To: T10 Technical Committee  
From: Barry Olawsky, HP (barry.olawsky@hp.com)  
Date: 10 July 2007  
Subject: T10/07-304r2 SAS-2 Zero-Length Test Load Section

#### 1.1.1.1 Zero-length test load

Figure 105 — Zero-length test load for transmitter device compliance point

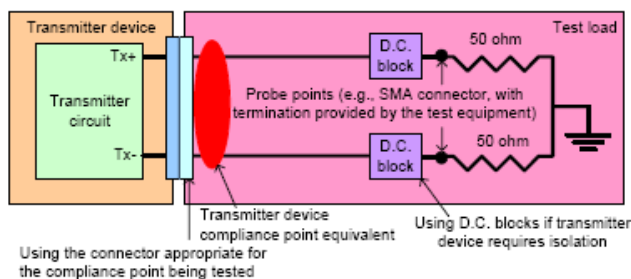
Test loads in a figure 105 and figure 106 show ideal designs. Actual designs include:

- insertion loss between the compliance and probe points; and
- return loss due one or more impedance mismatches between the compliance point and 50 ohm termination points.

Figure X, Zero-Length Sdd21

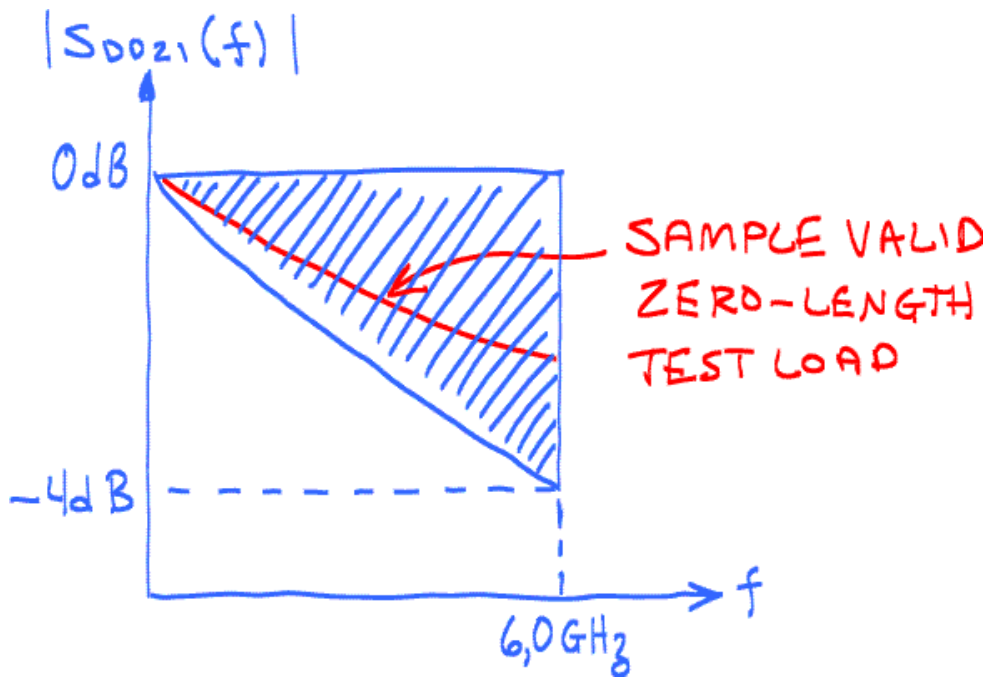
The zero-length test load, including all fixturing and instrumentation required for the measurement, shall comply with the following equations:

For 10 MHz  $\leq f \leq$  6,0 GHz:

$|S_{DD21}(f)| \geq -20 \log_{10}(e) \times ((1,0 \times 10^{-6} \times f_{0,5}) + (3,2 \times 10^{-11} \times f) + (5,3 \times 10^{-21} \times f^2))$  dB (see figure X)

$|S_{DD11}(f)| \leq -15$  dB

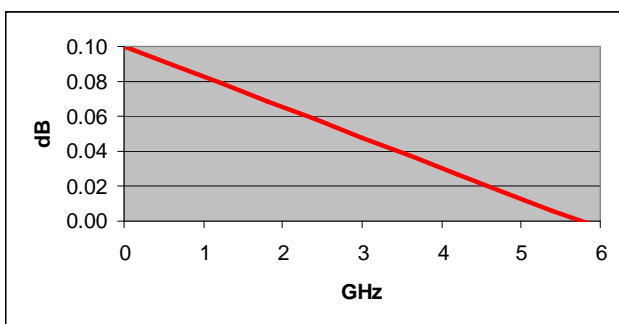
Adding a DC loss of 0.1dB and rescalling the “f” term to “3” to force 4.0dB loss at 6GHz the additional margin is:

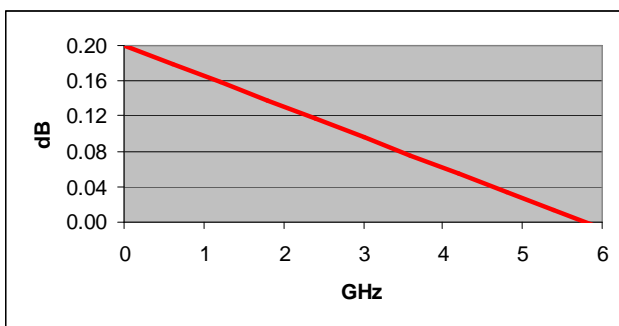
Adding a DC loss of 0.1dB and rescalling the “f” term to “2.8” to force 4.0dB loss at 6GHz the additional margin is:
